FLORIDA DEPARTMENT OF TRANSPORTATION - DISTRICT IV

FDOT District IV Attachment 1
PROJECT CONSUMPTION
Beacon Countyline DRI

FDOT District IV Attachment 1

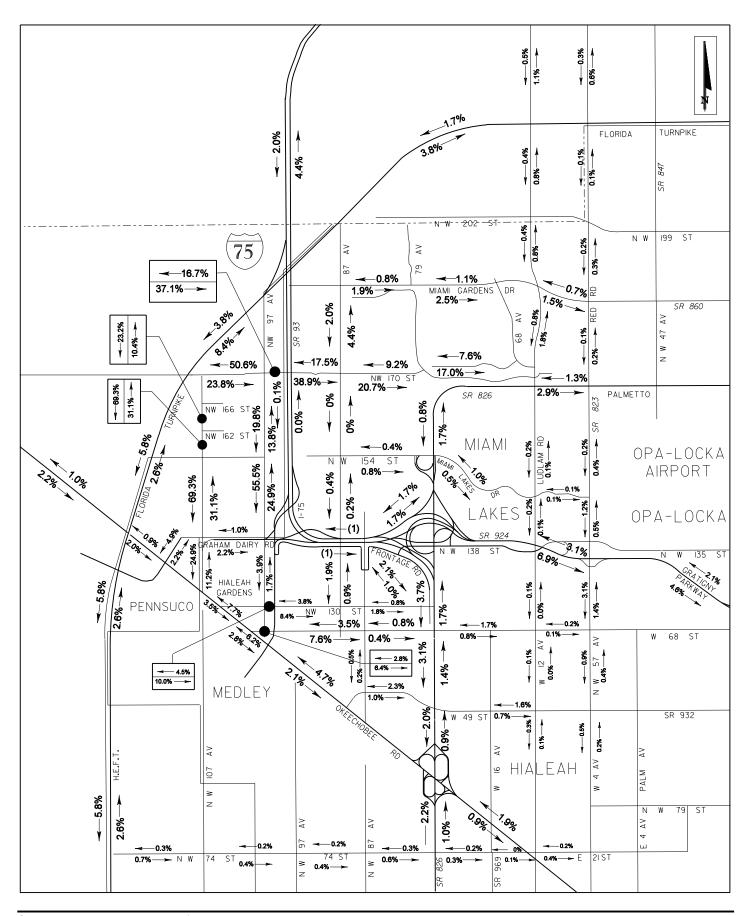
1. Previous Comment #17: Appendix 21-10, Model Outputs: The model output plots depicting the project traffic are unclear. Please provide a map showing project traffic percentages along all major roadways. Please clearly show the percent distribution from the project site; the percent assigned to external roads should add up to 100 percent. In addition, please track all project trip percentages until they are less than 5 percent of the adopted service volumes.

<u>FDOT Comment:</u> It is still unclear how the project traffic is assigned beyond NW 97th Avenue. Please clearly show the percent distribution from the project site; the percent assigned to external roads should add up to 100 percent, and track all project trip percentages until they are less than 5 percent of the adopted service volumes.

Applicant Response: Project assignment is included in Attachment 21-4.

<u>APPLICANT RESPONSE</u>: FDOT District VI Attachment 2 – Project Distribution and FDOT District VI Attachment 3 – Project Assignment provide the information requested and can be found in the response to FDOT – District VI. FDOT District IV Attachment 1 – Project Consumption shows consumption in the study area.
